SUBJECT: Environmental Permits for the Replacement of Bridge 29 on US 21
Business over I-77 in Yadkin County, Division 11, **TIP: B-5833.**

Action ID.: **SAW-2022-02123 B-5833** County: **Yadkin**

SUBJECT: Comments on GP/WQC Application for Replacement of Bridge 29 on US 21 Business over I-77, Yadkin County (**B-5833**)
DWR 20221363 ver.1

APPROVAL of 401 WATER QUALITY CERTIFICATION with ADDITIONAL CONDITIONS

PERMIT DRAWING
SHEET 4 OF 9

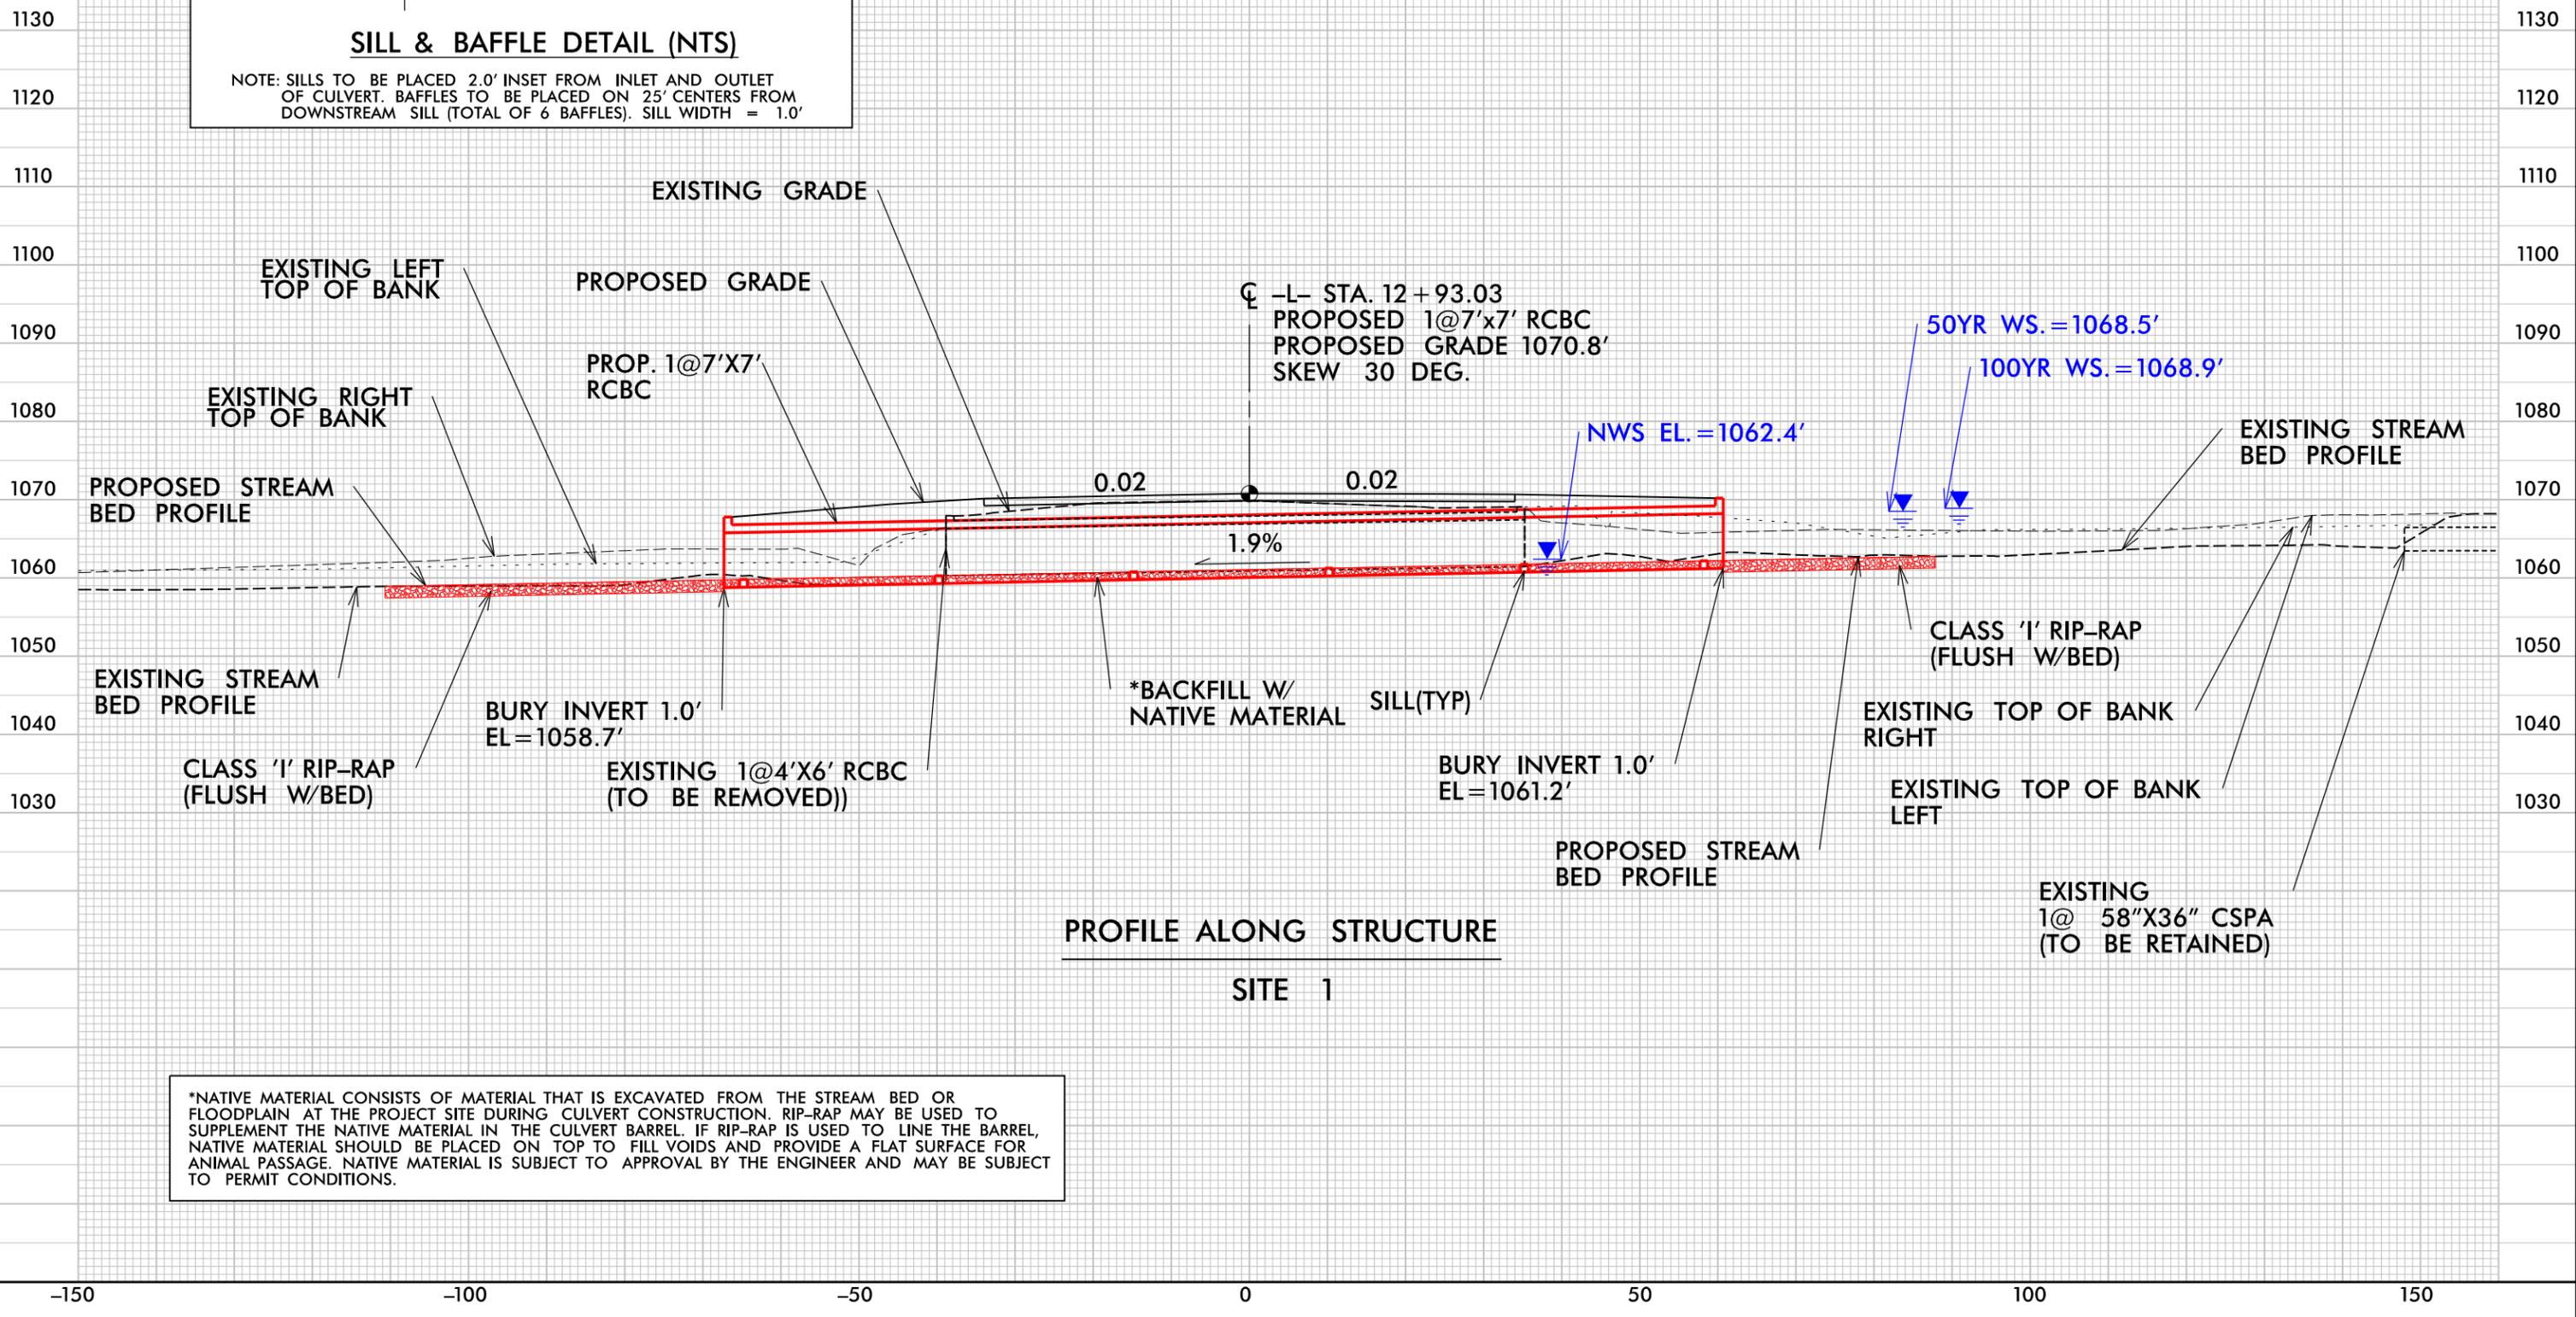
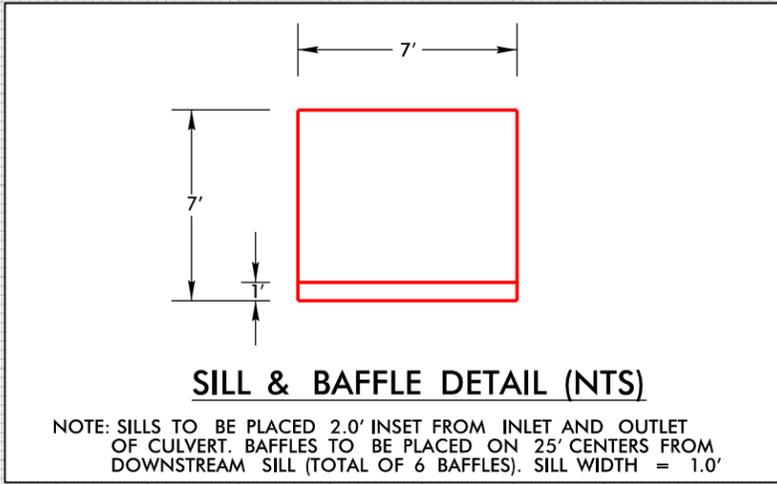
The NCWRC has no major concerns with this project but does recommend evaluating the native material before using it as the only backfill in the reinforced concrete box culvert (Site 1). The baffles and sills in this culvert should help retain this material, but very silty material, or material that was harvested with high amounts of subsoil, may be prone to washing-out. This has occurred on some similar projects, though most examples were RCBCs that did not have baffles (sills only). The NCWRC would support use of a mixture of rip rap with the native material (obtained either from on-site or purchased) if deemed necessary by the division environmental officer or project engineer. This is noted as an option in the drawings.
